CHAPTER 5 PNEUMATIC PUMPS

This chapter addresses the EPA's responses to public comments on pneumatic pumps in the EPA's Proposed *Oil and Natural Gas Sector: Emission Standards for New, Reconstructed, and Modified Sources*.

2.2.1 Pneumatic Pump Control Costs

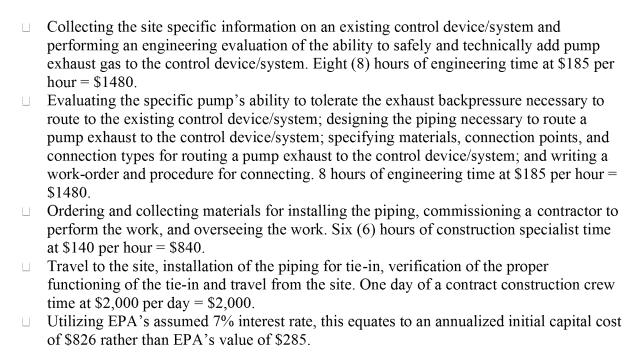
Comment: EPA estimated emission reductions and costs of controls for the production sector. A review of the cost analysis for the proposed controls for pneumatic pumps indicates that EPA underestimated costs and likely overstated emission reductions.

EPA estimated the cost of control, i.e., routing a pneumatic pump vent to an existing control device, as a one-time cost of \$2000. Using a 7 percent discount rate over 10 year estimated life of a pump, the annualized cost of control was estimated at \$285/year. EPA's reference for the cost estimated is from a NG STAR Fact Sheet for routing a glycol dehydrator circulation pump vent to an existing vapor recovery unit (VRU). The value assumed is an underestimate of the total cost that would be required for engineering design and piping installation for a vent system retrofit to route a very low flow, low pressure vent stream to an existing flare or VRU. This estimate is also inconsistent with the estimated cost of \$23,252 assumed for routing a wet seal compressor vent to an existing control device (Section 8.4.4.3 of TSD). ERM believes the value of \$23,252 is closer to the uninstalled capital cost that would be incurred. Utilizing EPA's assumed 7 percent interest rate, this equates to an annualized cost of \$3,308. Note that this estimate does not include the engineering and design analysis needed to ensure that the control device has adequate capacity and that the flow characteristics for a low flow, low pressure source can safely be routed into the existing flare or VRU header. The costs also do not include the recurring annual costs associated with monitoring and testing at sites not otherwise subject to Subpart OOOOa.

In the cost analysis for the proposed control strategy for pneumatic pumps, EPA incorrectly only listed a one-time capital cost impact of \$2,000 for the design and installation of piping to route vapors from the exhaust of a pneumatic pump to an existing control device. This value was based upon Natural Gas Star program data. Using a 7% interest rate, EPA estimated the annualized cost of controlling a pneumatic pump at \$285/year.

Response: The commenter has reviewed of the proposed costs for routing of a pneumatic pump's emissions to an existing control device, and expressed concerns that the costs are not representative of the true costs for the proposed control requirements. To preface a response on the scope of the concern about the costs, we note several changes made to the final rule that affect the discussions of costs presented in the comments:

Based on the detail provided by the commenters for their cost estimates, we believe these estimates are comparable to the proposed cost estimate. Therefore, we treated these estimates as additional cost estimates for connecting a pneumatic pump to an existing control device or process. To consider these additional estimates, we averaged these two estimates (\$5,800 and \$8,500 respectively) with the proposed capital cost of \$2,000 and estimated a revised capital cost of \$5,433 for this control option. Based on the 7 percent discount rate, we also calculated annualized costs of \$826 and \$1,210, respectively for the commenter cost estimates. We averaged those with the proposed annualized cost of \$285, and estimated a revised annualized cost of \$774, incorporating the additional costs presented by the commenters. We then used this revised annualized cost for the BSER analysis. As shown in the TSD to the final rule, we still consider the cost-effectiveness for this control option to be reasonable.
